# Read Me

## System Software 7.4.1 PATCH 9

## 1.7 MS-CHAP Authentication error between Windows clients and router

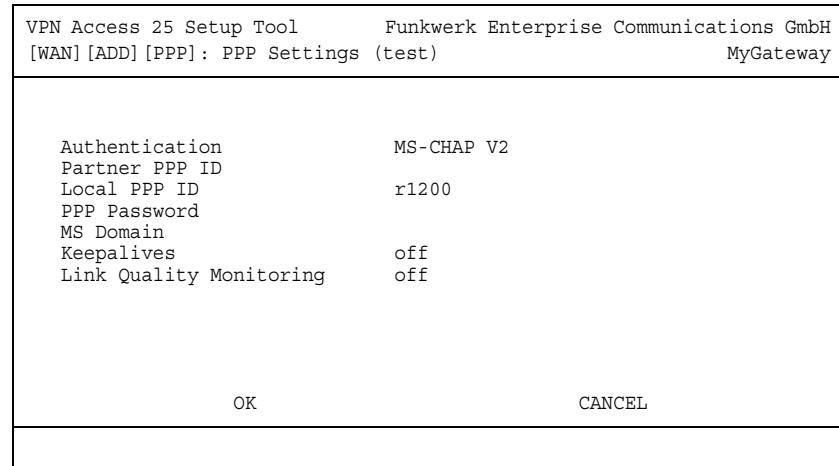
The authentication negotiation between Windows clients and the router sometimes failed for PPP or PPTP connections if the login name was used together with the domain name, for example, DEVELOPMENT\Developer.

In MS-CHAP V1 the entire identification name (domain and login name) is used for authentication.

In MS-CHAP V2 only the login name is used for authentication. The domain name is checked separately. To do so, the domain name must be entered in the new **MS DOMAIN** field. The field is only shown if **AUTHENTICATION = MS-CHAP, MS-CHAP V2 or CHAP + PAP + MS-CHAP**.

The problem has been resolved.

## 1.9 Cobion Orange Filter – Path depth setting

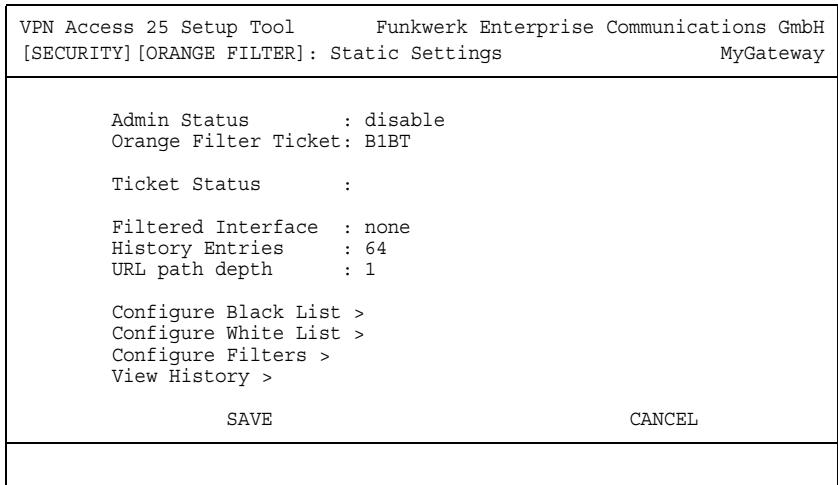
**VPN Access** allows you to enter the maximum path depth for the Cobion Orange Filter when scanning a URL.

Use the **URL PATH DEPTH** field to enter the maximum path level accessed when checking a URL.

When you enter *0*, only the URL domain name is checked (e.g., [www.server.com](http://www.server.com)). This means that all pages on this Web server belong to the same category.

When *1* is entered, the first level of the URL path is scanned. For example, [www.server.com/info](http://www.server.com/info) and [www.server.com/games](http://www.server.com/games) are checked separately and can be assigned to two different categories.

The higher the setting, the longer it will take to load Internet pages because each URL has to be checked for multiple categories. If you enter a value that is too low, no distinctions are made between any categories of directories below the set depth. The actual classification on the Cobion filter servers is not affected by this, but the processing speed increases since the check is not made down to the maximum depth (32).
